12180 GOODSON ROAD

PLOT PLAN

LOT 4, GUNNERS RIDGE
PLOT PLAN
PREPARED FOR: GJ GARDNER

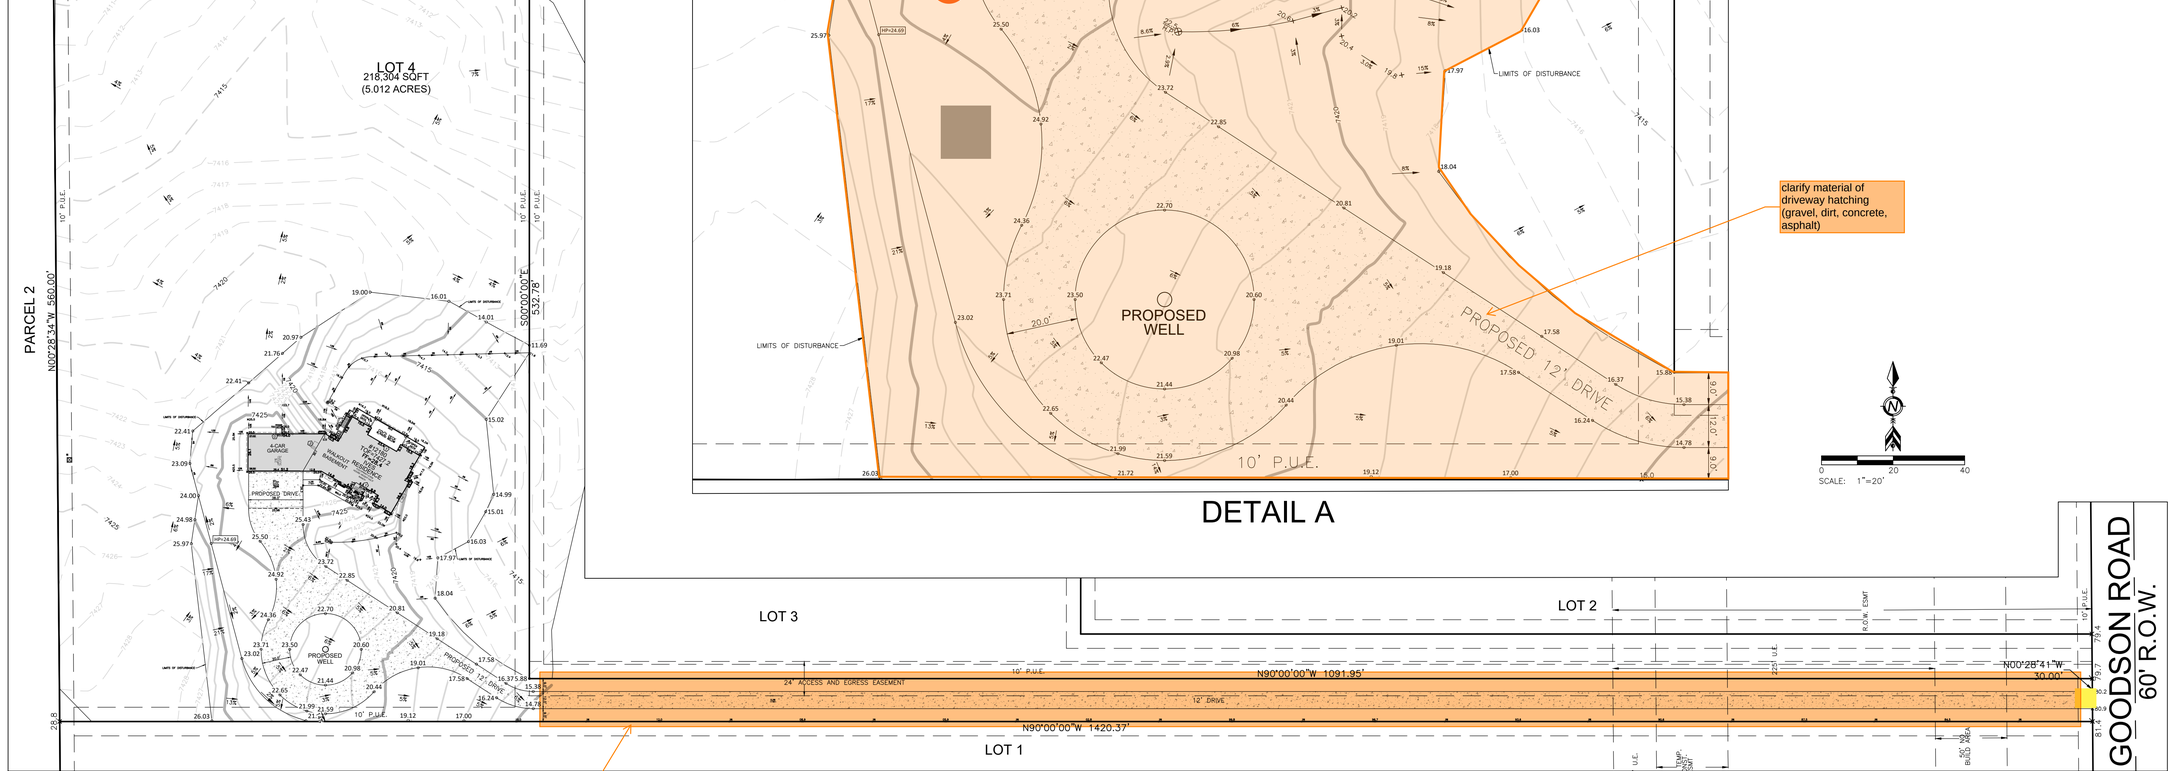
For lots like this where an AESQCP does not apply and the total lot is <35ac, the proposed disturbance must be <1ac to be applicable for a BESQCP. If soil disturbances are >1ac, an ESQCP is required which is a much more involved process with more documents required (mainly a drainage letter and SWMP), plus self and EPC inspections throughout construction. Which I'm assuming you don't want to do any of that. So here are some ideas to reduce your total proposed soil disturbance to <1ac:

- soil disturbance can be phased such that at any one time, you keep the disturbance to <1ac. So for examples: 1) once you pour the foundation, the footprint of the home would be removed from the soil disturbance and 2) once any disturbances are covered with gravel, they would be removed from the amount of disturbance too. So if you first grade and gravel the driveway, then that disturbance would be removed from your total. Also there is a big area of disturbance north of the home that could be saved for the end of the project, once more of the site is stabilized.

If you go this phasing route please add a note to this page clearly (but briefly) outlining your phasing plan. For example:

Limits of Disturbance:
Phase 1: 0.5ac for gravel driveway
Phase 2: 0.95ac for rest of site

Besides a note like that, would be good to delineate them on the map too.

Is this portion of the driveway already built? If not, it will need to be included in your proposed disturbance calc

clarify material of driveway hatching (gravel, dirt, concrete, asphalt)

The Site Map must be ~~drawn to scale, show the entire lot~~, and include the following:
~~- Existing structures~~
~~- Proposed development~~
- Total percent imperviousness of the site, to include both existing and proposed development in calculation. Consider all structures, porches, decks, patios, driveways, etc. Note that gravel is considered to be 80%.
~~- Flow arrows or contour lines showing the direction of stormwater flow on the lot~~
~~- Proposed limits of disturbance~~
- Proposed location of construction control measures (e.g., culvert protection, perimeter control, vehicle tracking control, concrete washout area, etc.)

I have crossed items that you have already included.
